UNITED STATES PATENT AND TRADEMARK OFFICE

10/646,478

Office Action Summary

DETAILED ACTION

FIG. 6

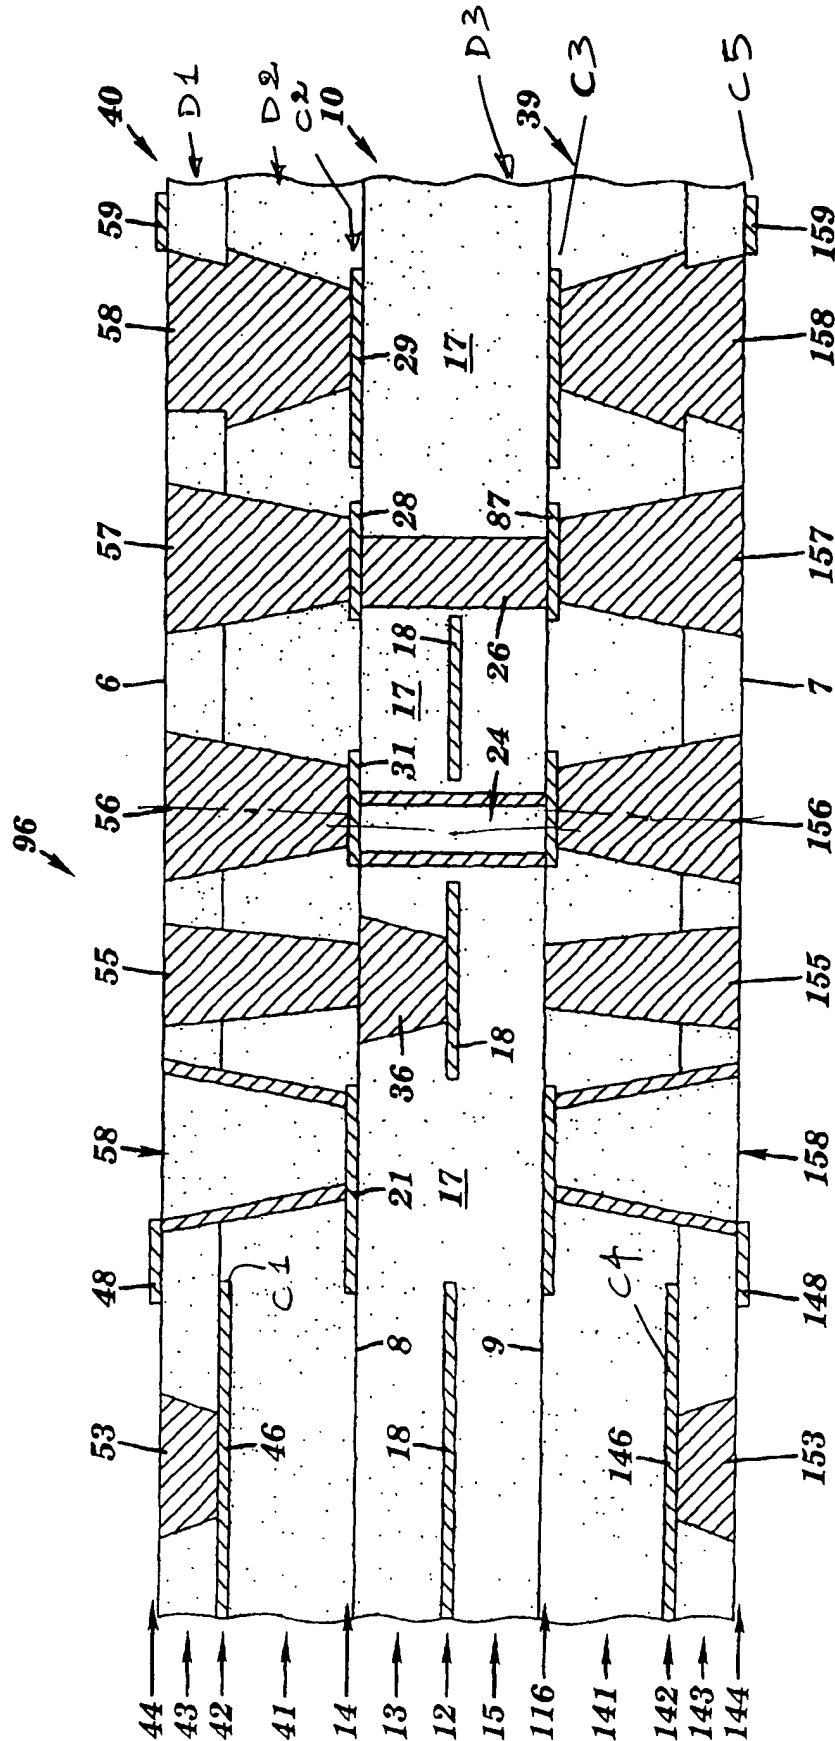
Regarding claim 40, Carpenter, in figure 6, discloses a substrate comprising: a first dielectric layer (D1, as marked up on figure 6 in appendix "A"); a second dielectric layer (D2, as marked up on figure 6 in appendix "A"); a first conductive layer (C1, as marked up on figure 6 in appendix "A"); between the first and second dielectric layers; a third dielectric layer (D3, as marked up on figure 6 in appendix "A"); the second dielectric layer being between the first and third dielectric layers; a second conductive layer (C2, as marked up on figure 6 in appendix "A"); between the second dielectric layer and the third dielectric layer, the second conductive layer including a first skip via (57) that extends through the first and second dielectric layers; and a third conductive layer (C3) on the third dielectric layer, the third conductive layer including a second via (26) that extends through the third dielectric layer, the second via and the first skip via being stacked on top of one another (see marked up figure 6 in appendix "A").

Regarding claim 41, Carpenter further discloses the first skip via includes a longitudinal axis (longitudinal axis passing through the first skip via, see marked up in figure 6, in appendix "A") and the second via includes a longitudinal axis (longitudinal axis passing through the second via, see marked up in figure 6, in appendix "A"), the

longitudinal axis of the first skip via being substantially aligned with the longitudinal axis of the second via (see marked up in figure 6, in appendix "A").

Regarding claim 42, Carpenter further discloses the first, second and third dielectric layers are formed on a core (C5, see marked up in figure 6, in appendix "A").

Regarding claim 43, Carpenter further discloses a fourth conductive layer (C4, see marked up in figure 6, in appendix "A") between the first dielectric layer and the core.

FIG. 7

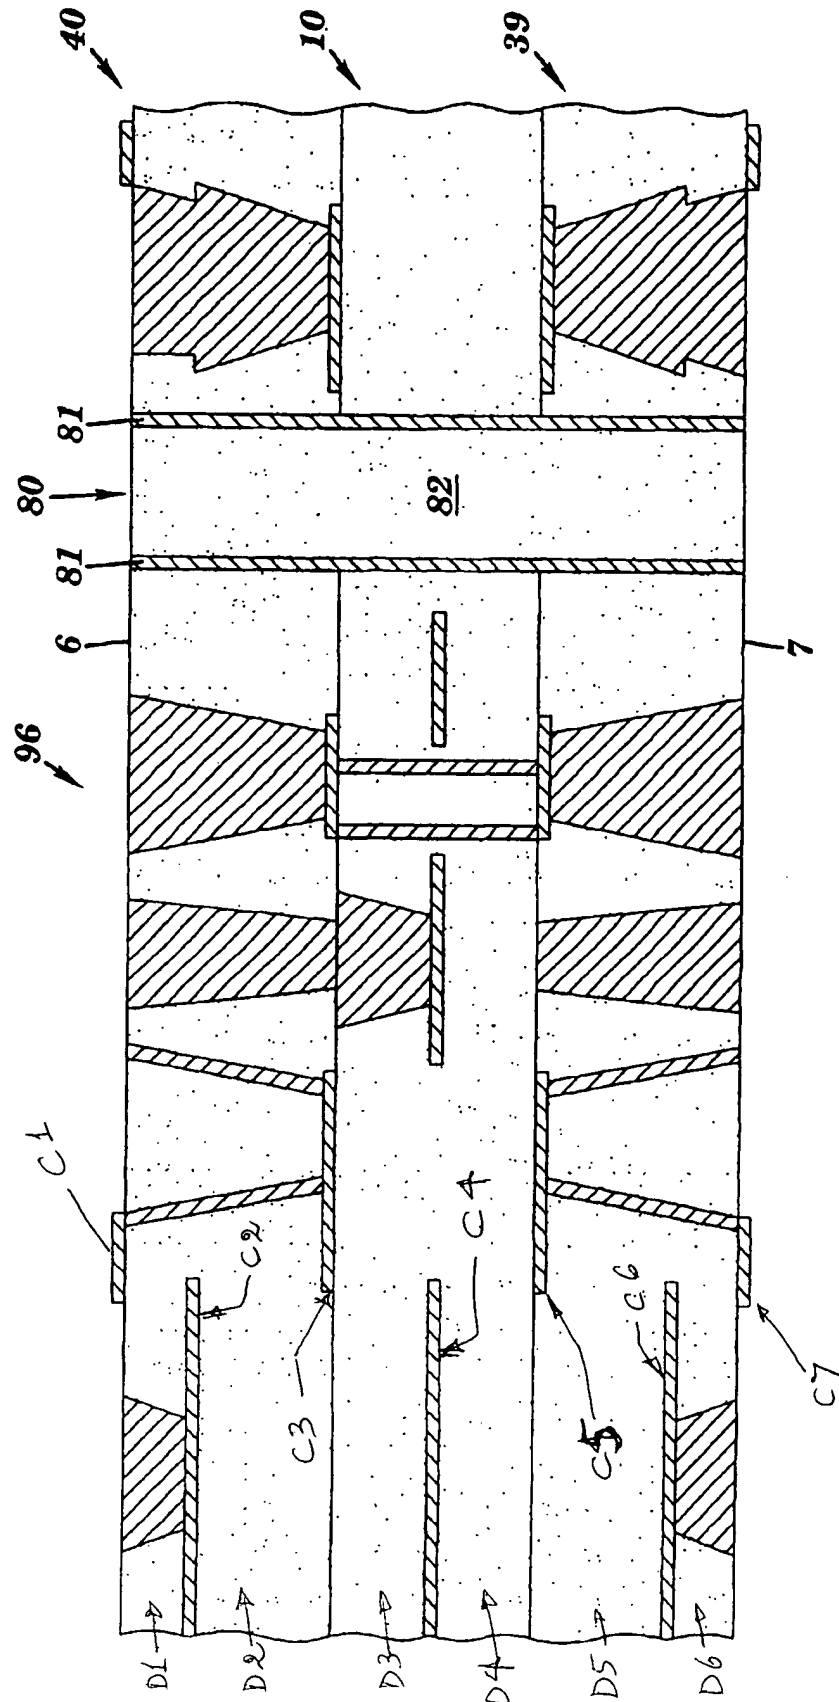
Regarding claim 47, Carpenter, in figure 7, discloses a substrate comprising: a first dielectric layer (D1, marked up on figure 7 in appendix "B"); a second dielectric layer (D2, marked up on figure 7 in appendix "B"); a first conductive layer (C2, marked up on figure 7 in appendix "B") between the first and second dielectric layers; a third dielectric layer (D3, marked up on figure 7 in appendix "B"), the second dielectric layer being between the first and third dielectric layers; a second conductive layer (C3, marked up on figure 7 in appendix "B") between the second and third dielectric layers,

the second conductive layer including a first skip via (V1, marked up on figure 7 in appendix "B") that extends through the first and second dielectric layers; a fourth dielectric layer (D4, marked up on figure 7 in appendix "B"), the third dielectric layer being between the second and fourth dielectric layers; a third conductive layer (C4, marked up on figure 7 in appendix "B") between the third and fourth dielectric layers; and a fourth conductive layer (C5, marked up on figure 7 in appendix "B") on the fourth dielectric layer, the fourth conductive layer including a second skip via (V2, marked up on figure 7 in appendix "B") that extends through the third and fourth dielectric layers, the second skip via and the first skip via being stacked on top of one another (see marked figure 7 in appendix "B").

Regarding claim 48, Carpenter further discloses the first skip via and the second skip via each include a longitudinal axis (longitudinal axis of axis of first skip via and second skip via), the longitudinal axis of the first skip via being substantially aligned with the longitudinal axis of the second skip via (see marked up figure 7 in appendix "B").

Regarding claim 49, Carpenter further discloses the first, second, third and fourth dielectric layers are formed on a core (C7, as marked up on figure 7 in appendix "B").

Regarding claim 50, Carpenter further discloses a fifth conductive layer (C6, marked up on figure 7 in appendix "B") between the first dielectric layer and the core.

Regarding claim 54, Carpenter discloses all the features of the claimed invention as applied to claim 47 above, including a fifth dielectric layer (D5, marked up on figure 7 in appendix "B"), the fourth conductive layer (C5, marked on figure 7 in appendix "B") being between the fourth and fifth dielectric layers; a sixth dielectric layer (D6, marked up on figure 7 in appendix "B"), the fifth dielectric layer being between the fourth and sixth dielectric layers; a fifth conductive layer (C6, marked up on figure 7 in appendix "B") between the fifth and sixth dielectric layers; a sixth conductive layer (C7, marked up on figure 7 in appendix "B") on the sixth dielectric layer. Carpenter further discloses a third sip via (V3, marked up on figure 7 in appendix "B"), a third skip via that

extends through the fifth and sixth dielectric layers, but does not disclose the sixth conductive layer including connected to the third skip via. However, as can be seen at various places in the figure, the conductor layer / patterns are connected to the via depending upon the desired electrical connection for signal, power or ground connections.

Regarding claim 55, Carpenter further discloses the first, second and third skip vias each include a longitudinal axis, the longitudinal axis of the first skip via being substantially aligned with the longitudinal axis of the second and third skip vias (see marked up figure 7 in appendix "B").

Regarding claim 56, Carpenter further discloses the first, second, third, fourth, fifth and sixth conductive layers are patterned conductive layers (see figure marked up figure 7 in appendix "B").

Fig. 6

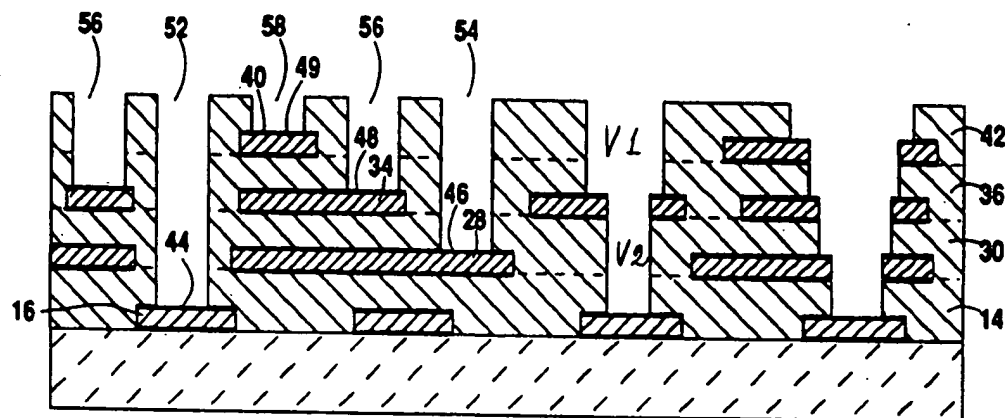
Regarding claim 40, Kumar, in figure 6, discloses a substrate comprising: a first dielectric layer (41); a second dielectric layer (36); a first conductive layer (42); between the first and second dielectric layers; a third dielectric layer (14); the second dielectric layer being between the first and third dielectric layers; a second conductive layer (34) between the second dielectric layer and the third dielectric layer, the second conductive layer including a first skip via (V1, as marked on figure 6 in appendix "C") that extends

through the first and second dielectric layers; and a third conductive layer (16) on the third dielectric layer, the third conductive layer including a second via (V2, as marked on figure 6 in appendix "C") that extends through the third dielectric layer, the second via and the first skip via being stacked on top of one another (see marked up figure 6).

Regarding claim 41, Kumar further discloses the first skip via includes a longitudinal axis (longitudinal axis passing through the first skip via, V1, see marked up in figure 6, in appendix "C") and the second via includes a longitudinal axis (longitudinal axis passing through the second via, V2, see marked up in figure 6, in appendix "C"), the longitudinal axis of the first skip via being substantially aligned with the longitudinal axis of the second via (see marked up figure 6, in appendix "C").

Fig. 6F

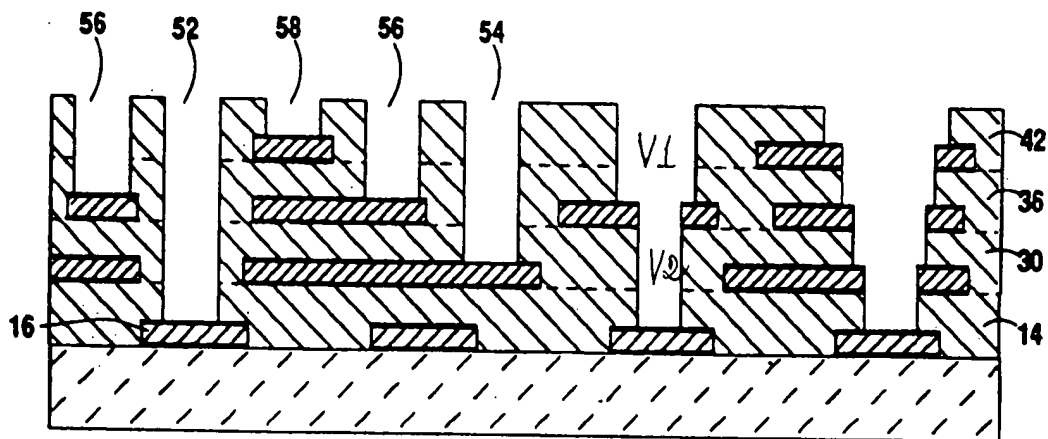
Regarding claim 47, Kumar, in figure 6F, discloses a substrate comprising: a first dielectric layer (42); a second dielectric layer (36); a first conductive layer

(conductive layer between the dielectric layer 42 and 36) between the first and second dielectric layers; a third dielectric layer (30), the second dielectric layer being between the first and third dielectric layers; a second conductive layer (conductive layer between the dielectric layer 36 and 30) between the second and third dielectric layers, the second conductive layer including a first skip via (V1, as marked on figure 6F in appendix "D") that extends through the first and second dielectric layers; a fourth dielectric layer (14), the third dielectric layer being between the second and fourth dielectric layers; a third conductive layer (conductive layer between the dielectric layers 30 and 40) between the third and fourth dielectric layers; and a fourth conductive layer (conductive layer on dielectric layer 14) on the fourth dielectric layer, the fourth conductive layer including a second skip via (V2, as marked on figure 6F in appendix "D") that extends through the third and fourth dielectric layers, the second skip via and the first skip via being stacked on top of one another (see marked up figure 6F).

Regarding claim 48, Kumar further discloses the first skip via and the second skip via each include a longitudinal axis (longitudinal axis of axis of first skip via V1 and second skip via V2), the longitudinal axis of the first skip via being substantially aligned with the longitudinal axis of the second skip via (see marked up figure 6F in appendix "D").

Regarding claim 51, Kumar further discloses the first, second, third and fourth conductive layers are patterned conductive layers (see figure 6F).
